**Addendum # 1
Originated by
OFFICE OF THE STATE ENGINEER**

January 18, 2019

Project: Family Living Center Bathroom and Windows Renovation
STATE FAIR GRANDSTAND
HURON, SOUTH DAKOTA
OSE#: M2318 – 08X/SWMR

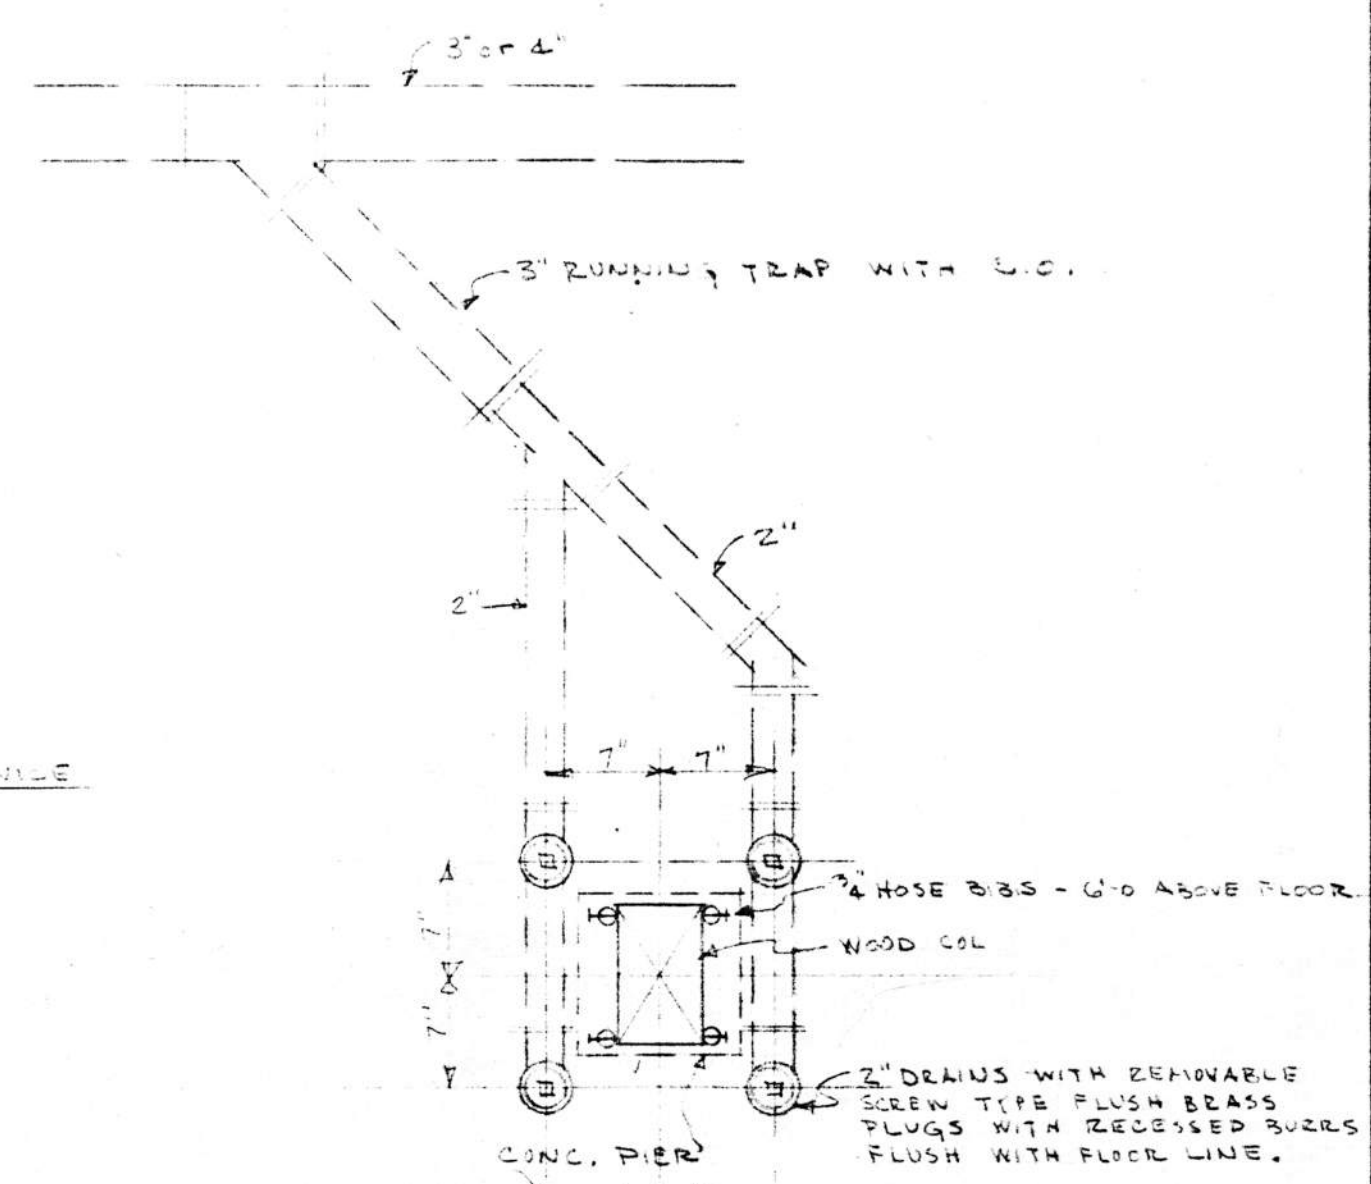
- Item No. 5 Page 5 of 7 Women's Restroom, Remove existing hand dryer and Install two hand dryers in current location. Framing for new hand dryer will same type existing. The existing framing consists of two 1/2" Plywood layers mounted to the face of the CMU wall.
- Item No. 6 Page 5 of 7 Women's Restroom, Provide and install 5 Sanitary-Napkin Disposal Units. Exact location in Toilet Stall shall be coordinated with the owner.
- Item No. 7 Page 5 of 7 Women's Restroom, Remove existing mirrors, provide and install 18" x 24" mirrors at the existing locations. Total of 3 mirrors.
- Item No. 8 Page 5 of 7 Women's Restroom, Grind boxed area, in picture below, flat and patch area with mortar to a level finish. Approximately 2' x 2' area.
